Attachment A

<u>Remove</u>		<u>Insert</u>
page	3.11-2	page	3.11-2
	3.11-4		3.11-4
	5.4-2 to 5.4-4		5.4-2 to 5.4-4
figure	5.4-1	figure	5.4-1

# CRITICALITY SAFETY ANALYSIS FOR THE STORAGE OF CONSOLIDATED FUEL RODS IN REGION 2 OF THE GINNA MDR SPENT FUEL STORAGE RACKS

SUBJECT: Consolidated Fuel Storage

FIGURE 5.4-1

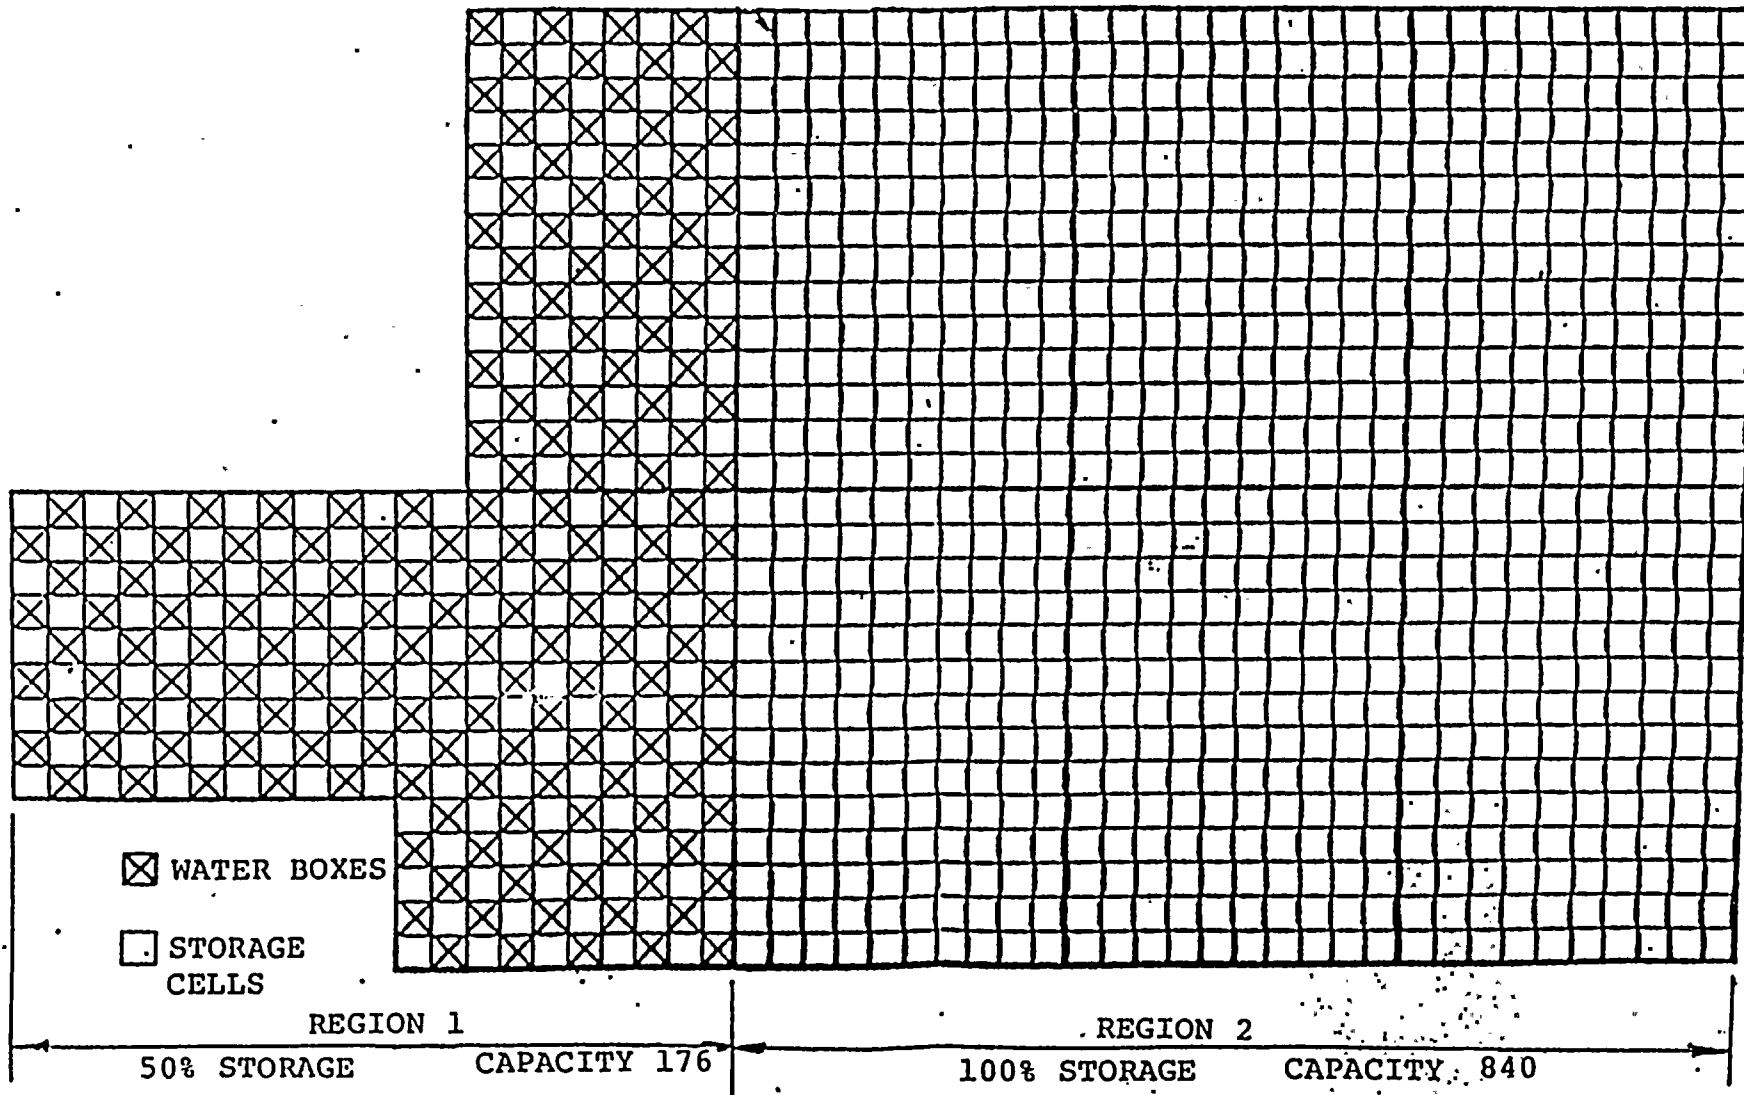
\*TOTAL CAPACITY 1360 Fuel Assemblies

Total Capacity includes provisions for storage of consolidated fuel.
